PROPOSAL FOR NEW CRITERIA FOR HEADFORM IMPACTOR TO BONNET TESTS AND JUSTIFICATION

Proposal for new wording of the criteria (GR PS 143 Rev1):

Figure 1

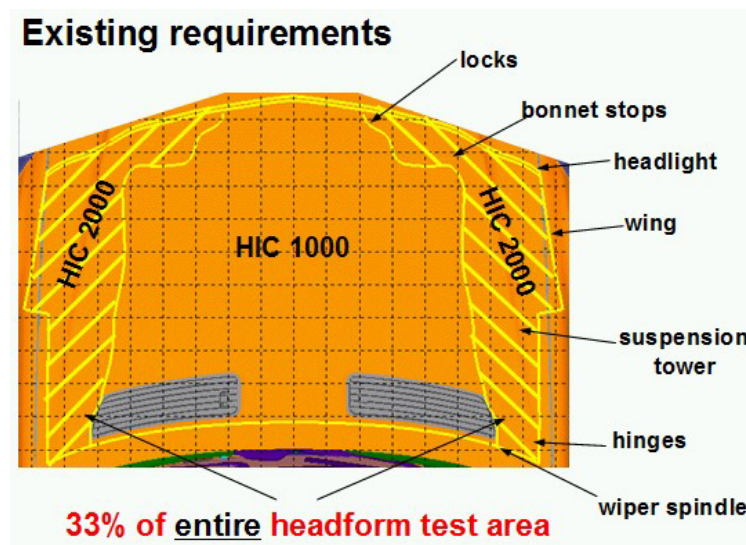
Necessary under-bonnet components such as locks, suspension tower, etc. will not fundamentally change in their position. They need to be located in the child headform test area. This often results in more than 33% of relaxation zone for the child test area alone (Figures 1 and 2).

The combination of a significantly reduced maximum HIC value of 1700 and a relaxation zone maintained at 33% means that the above-mentioned first approach is technically unfeasible.

“The HIC recorded shall not exceed 1000 over one half of the child headform test area and, in addition, shall not exceed 1000 over 2/3 of the combined child and adult headform test areas. The HIC of the remaining areas shall not exceed 1700.”

Figure 3

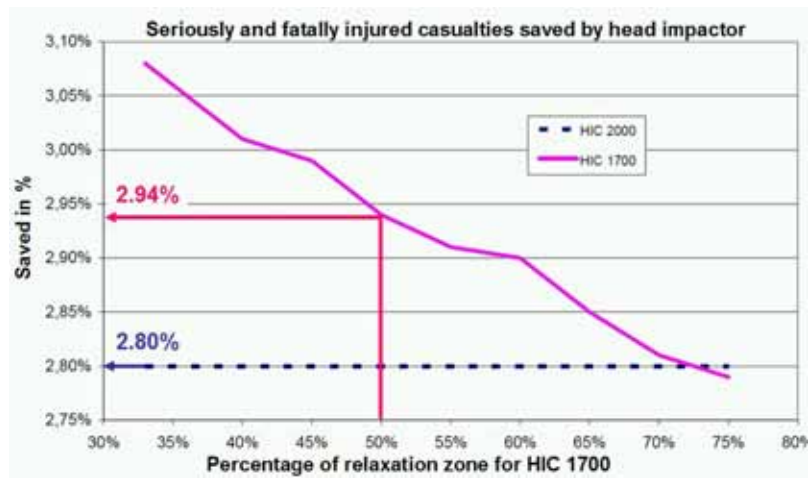
Figure 3 compares the effectiveness (percentage of saved pedestrians) in the bonnet test area for existing regulations (HIC below 2000 in 33% of the entire test area) and for this alternative approach (HIC below 1700 in x% of the test area). The calculation method is the same as the one used by TRL in the study carried out for the European Commission.

The comparative effectiveness diagram shows that more pedestrians would be saved even if the relaxation zone of the bonnet test area is around 50%. This improvement is due to the significantly reduced HIC limit of 1700.
